# DRAFT- DOH Review: Navy Groundwater Flow Models & Related Issues with the Navy CSM for the Red Hill Facility

The Department of Health Hawaii (DOH)

October 19, 2021

Figure 5.1.1-7, Redacted GWFM Rept, Mar 2020

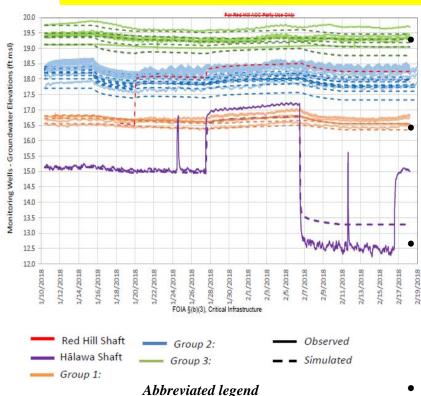
(GWFMs apparent mismatch to g.w. elevations)

#### Non-Uniform Distance Drawdown Behavior

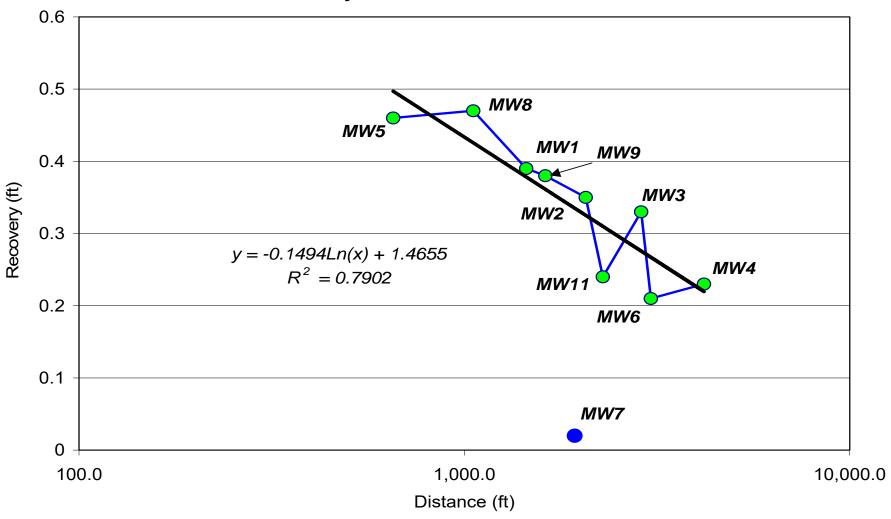
(indicates complexities not captured by models)
